APPROVED MINUTES OF THE MEETING

October 15, 2009

SPU Director
Thomas Street Pedestrian Bridge
Fire Station 6 Central District
University of Washington West Campus

Schematic Plan

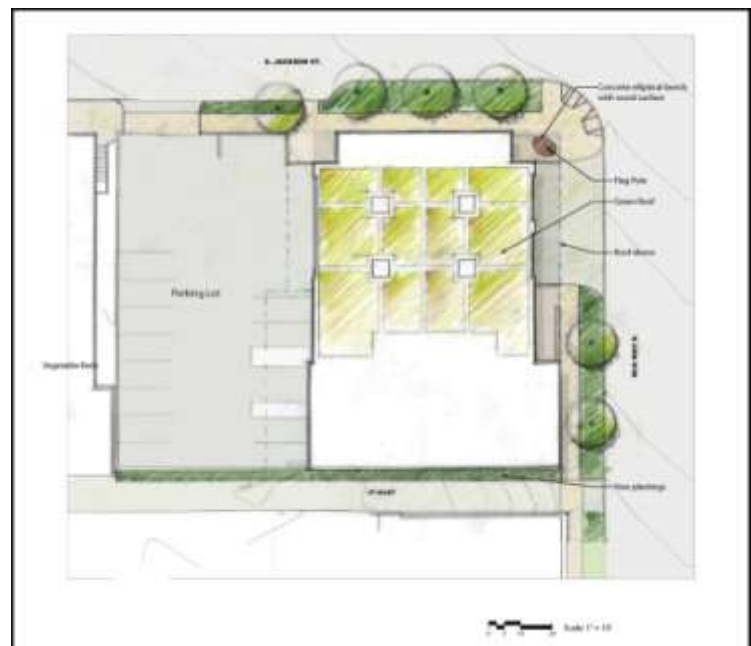
The Design Commission thanked the design team for the presentation of the plans for Fire Station 6. The Commission unanimously approves schematic design of the project as presented. The Commission noted that the development of the plans since the last presentation was impressive. The architectural strategy of the central stairway form has really gelled this design.

- The Commission supports the use of a curb bulb along S. Jackson St. for public use, if SDOT finds the area is not needed as a traffic lane.
- If the curb bulb is developed, the design should offer much beyond the basic street tree planting strip. It should be used to maximize the corner, increasing the permeability, public use and dialog of the corner of the site to the neighborhood.
- The Commission asks that the options for providing permeability of the north façade be narrowed but remain open in Design Development.
- Along the north façade, condense the storage areas and consolidate the in-between spaces. Although it's not necessary to keep them uniform, consider keeping the corners open at both ends.

- Commissioners applaud the idea of the perforated overhang/eyebrow along the north of the building. Consider plantings on the roof of it.
- See that the trees in the proposed curb bulb along the façade are of an appropriate scale.

- Continue to develop the S. Jackson St. façade with a mind to the pedestrian experience. Bring integration of the fence and façade, and continue to find transparency solutions.

- Consider the art as it will be experienced from near and also from a more distant point.
- The Commission urges the architects and artist not to relegate the art to the north wall but to allow the art into a holistic approach to opening the site at the corner and providing a friendly pedestrian environment along Martin Luther King Jr. Way.

- Further explore the entrance along Martin Luther King Jr. Way and its function as a public entrance to the building.
- The use of a canopy of trees at the south west corner of the site juxtaposes with the neighborhood in an important way.

For the fence on north side, I would vote for more transparency. The railing of the balcony could be the same for continuity.

Thank you for addressing permeability on the north side. Treat the glass as the punched opening; it still needs to read as a box. I'm not sure all the punched openings need to be symmetrical.

On the north side, you need to carefully pick the trees. Creating an overhanging eave and puncturing it is a great idea. The flagpole could be mounted on the building itself, which might give you some freedom on the corner. The entrance doesn't read as an entrance yet.

I worry the numerous nooks inside will be filled with boxes, or if the nooks are outside they will be filled with trash. If you're subdividing the box on the north wall, shrink it down and keep it simple.

I have concerns that the MLK façade is too blank, especially the southern section. I also have concerns about the Jackson side; you need more options than just the alternatives of one concept. A lot hinges on the curb bulb being accepted by SDOT. This needs to actually be space, not just a planting area. You need to look at the species you plant. You should green up the parking lot. The fencing along Jackson needs to be integrated and as transparent as possible. The drive-through imperative creates a loss for the pedestrian experience.

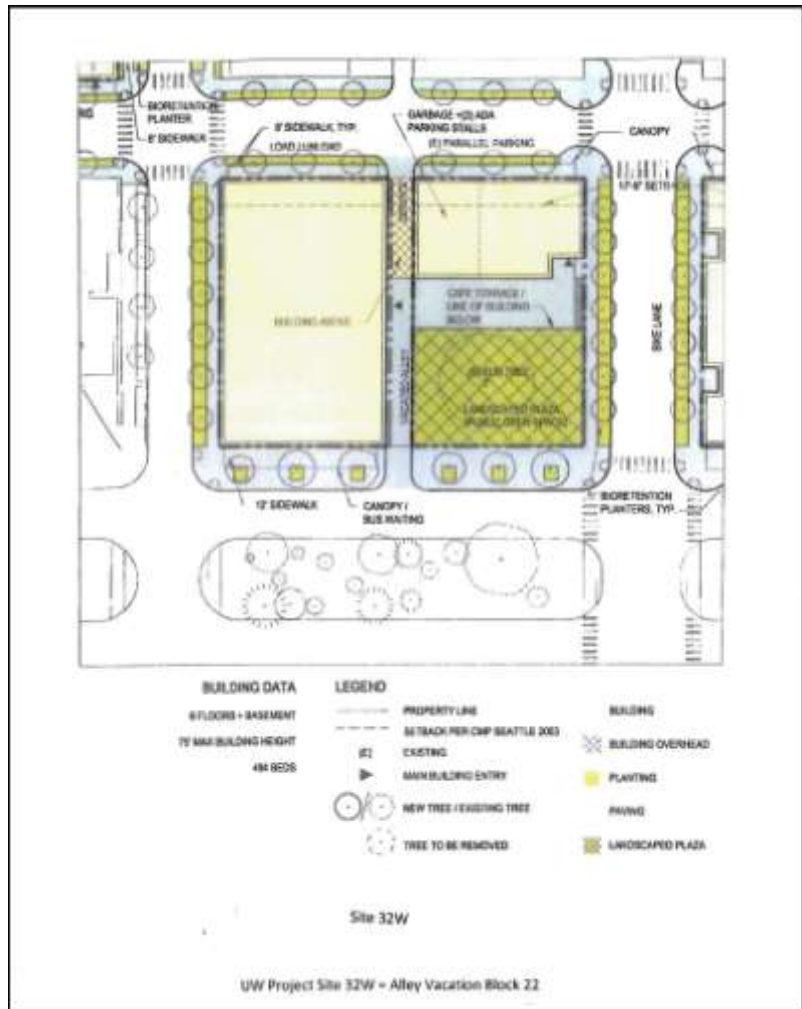
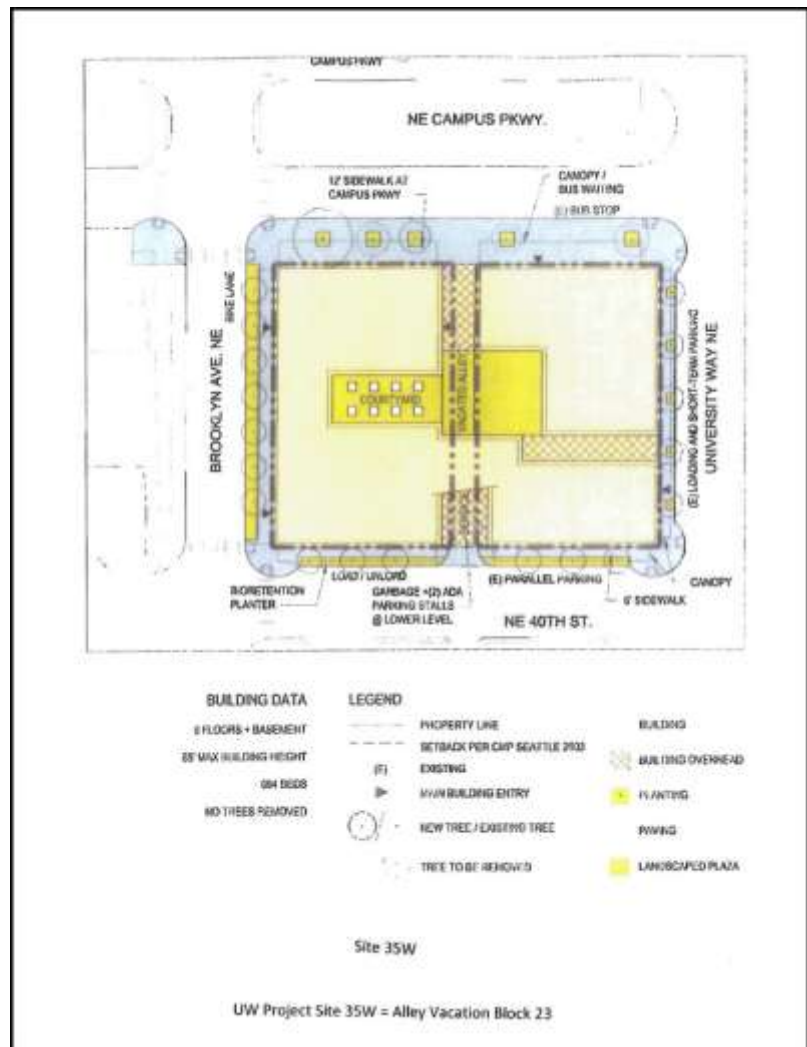
Generally, the Commissioners saw the four urban design merit criteria better met in 32W than in 35W. There was concern that 35W as designed wouldn't contribute to a positive urban design situation as much as 32W would, and might even be a detriment.

- Please show the property line, the delineation of the passthrough pathways etc.
- There is concern over the solar access at the public space at 35W because it is located inside the block.
- While the urban market is seen as a positive feature, consider how the use will interface with the public open spaces of the building.
- There is also concern over what would happen if the large tree that the public plaza in 32W is created around were to be removed eventually.
- To increase the quality of the open spaces around the site, consider breaking down the scale on both sides of 35W.

- In the next presentation please include information on pedestrian counts around the site and in the vicinity. Include sidewalk dimensions.
- In designing the right of way improvements, celebrate the transit oriented nature of the project.

35W is going to read as space that serves the students. You will have a hard time selling it as a public benefit.

I'd like to hear more about the conflict of pedestrians, waste removal and parking under the tree at 32W. The main entrance to the building is right there. How is that going to operate? If the bollards are moved back, what will stop others from stopping there?

My concerns tie to the nature of 35 and whether it is public. There is great treasure in the elm plaza. We need to future-proof the public space, to prevent it being used in the future.

For Site 32, I see the urban merit. For Site 35, it is inward focused. I'd rather seen it turned inside out. I don't see an urban merit now for 35.

The goat path diagram was deceptive. People move along a rectilinear grid. What I see is an interruption of a view corridor for 35W. We need to look at what would be a good design without the vacation. Have you calculated the public benefit? I don't see the urban design merits yet. Definitely not for 35, and for 32 I don't see the merits either.

For 35, I think we're taking away view and light corridors. I do appreciate 32W.

32 seems more obvious to me. I have a hard time with 35; it is half-way there. Need to know about the south side of 35. What is the view corridor? Is it significant?

We are trying to make it feel like a pedestrian environment. We are trying to maximize the pickups by using compactors; we expect once every two weeks for trash pick-up. We schedule the visits, early in the morning. The building staff will monitor the use.
